SERVICE LETTER 241

Cessna 206 Hydraulic Pump Replacement FWD Installation Near Wheel Well on 3450A Floats

Aircraft Makes/Model(s):	Float Model(s):	Compliance: Optional	By: MAS
Textron Aviation 206-206G, 206H, T206H	3450A	Part Number: 1011989	Approved: SDW
		Date: 12/22/2021	Revision: A

12 VDC ONLY

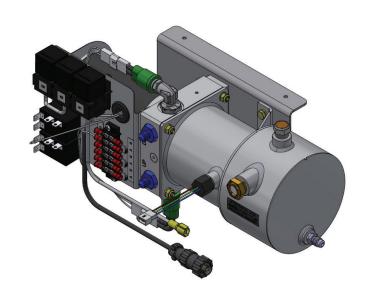
DISCONTINUED OILDYNE 12 VDC HYDRAULIC PUMP 34A09000-245

NEW 12 VDC HYDRAULIC PUMP 1011938

24 VDC ONLY

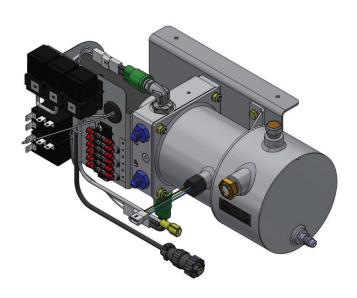
DISCONTINUED OILDYNE 24 VDC HYDRAULIC PUMP 34A09000-277

NEW 24 VDC HYDRAULIC PUMP 1011939
